VILLAGE OF LOMBARD  
REQUEST FOR BOARD OF TRUSTEES ACTION  
For Inclusion on Board Agenda

TITLE: PC 16-18; Parcel 2 of Yorktown Commons Planned Development (50 Yorktown Center)

**SUBJECT:** **PC 16-18, Parcel 2 of Yorktown Commons Planned Development (southeast corner of Grace Street and Yorktown Ring Road)**

**Subject: PC 16-18, Parcel 2 of Yorktown Commons Planned Development (southeast corner of Grace Street and Yorktown Ring Road)**

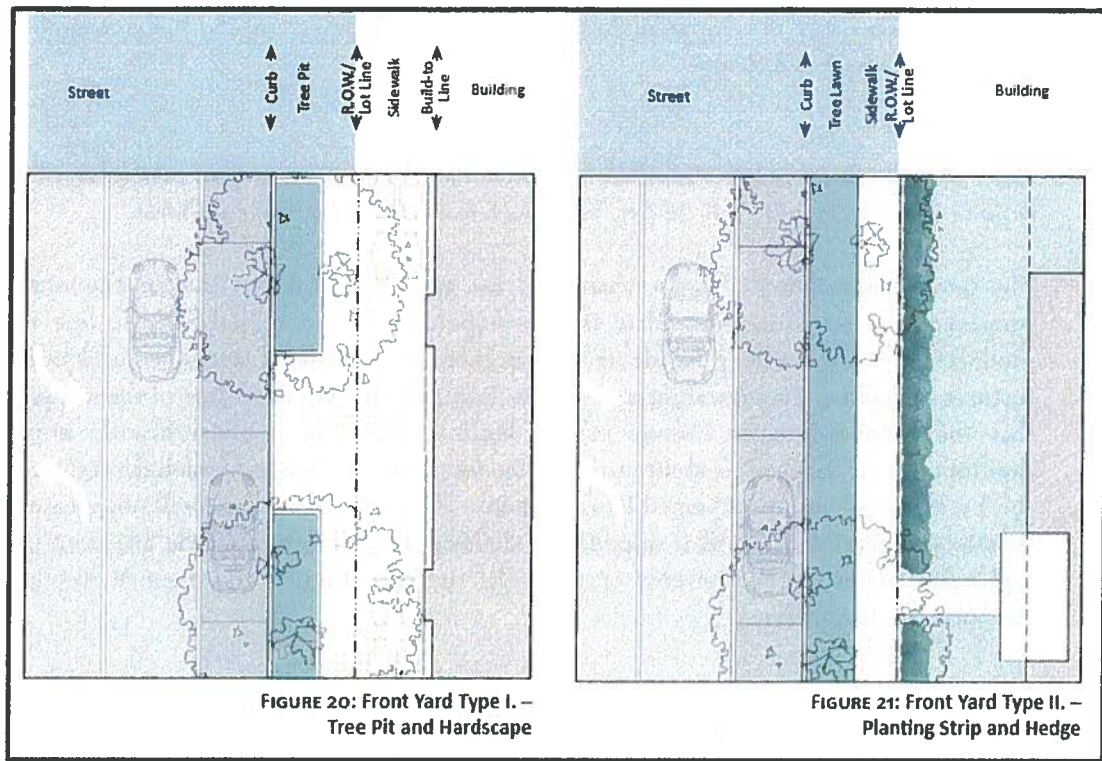
- E. *Major Change – Build-to line: Amend the build-to line for the northern side of the subject property to allow for a build-to line ranging from 21 feet to 68 feet, where a 20-foot build-to line was established.*

The petitioner requires a major change to the approved build-to line for the north side of the property in order to accommodate the development. The proposed building includes a resident and visitor drop-off area along the ring road frontage, with the result that portions of the building will have a significant setback from the property line. The drop-off area does incorporate a canopy that extends almost to the sidewalk and helps to maintain a pedestrian-appropriate sense of scale. The petitioner further points out that the drop-off area will serve to move vehicle loading and delivery activity away from the ring road.

Upon review of the site plan, staff finds that the proposed major change in this build-to line will not significantly impact the final development in terms of its ability to meet the intent of the Design Guidelines and the objectives of the Yorktown Commons Planned Development. The requested change will not create public health or safety concerns, nor will it impede the developer's ability to provide adequate public utilities and infrastructure improvements or meet the overall intent of the planned development. Staff supports this major change.
